Product Update

Document Number: 9AKK108469A9619, Rev A	Issue Date: 8/15/2024
Modular Metering Global Product Manager: Adam Busocker	Products Impacted: Ringless Modular Metering (See list of Materials below)
R&D Manager: Heather LeBlanc	Impact to Form/Fit/Function: None

The purpose of this communication is to inform you about a drawing update for the following ReliaMod Modular Metering – Ringless drawings. **No current product changes are occurring, but the nomenclature to describe a particular design feature will change.**

Example drawing 1 :

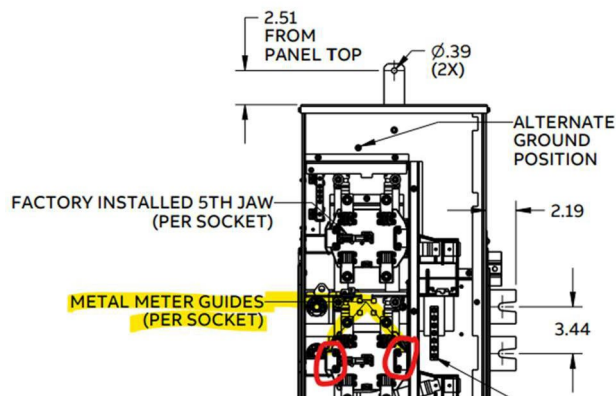
Outline drawings for Ringless ReliaMod Modular Metering products can be found in the BuyLog-Section 2, EMPOWER, and the ABB library. The drawings point to the “Metal Meter Support Bracket”, but refer to these items as “Metal Meter Guides”.

1. Update ReliaMod Modular Metering – Ringless only drawings. Remove the words and arrows (in yellow highlight) from the Example Drawing 1 drawing.
2. The new outline drawings shall include a reference to a metal meter guide kit (RMMETALMETERGUIDE), for customers who request the kit .
3. Upload the new drawings to EMPOWER and the ABB Library.

Example Drawing 2:

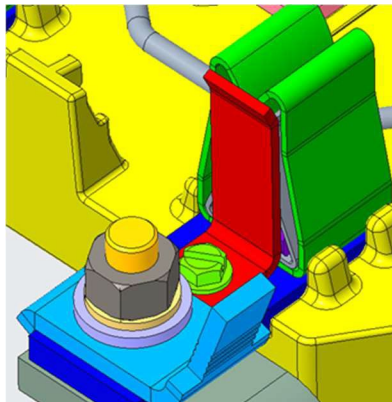
The phrase “metal meter guide” commonly describes a piece of metal that is set very close to the jaws of a meter socket (See the Red object in the Example Drawing 2). Certain utilities may specify these items to further guide the placement of the watt-hour meter blades into the socket jaws prior to meter cover installation.
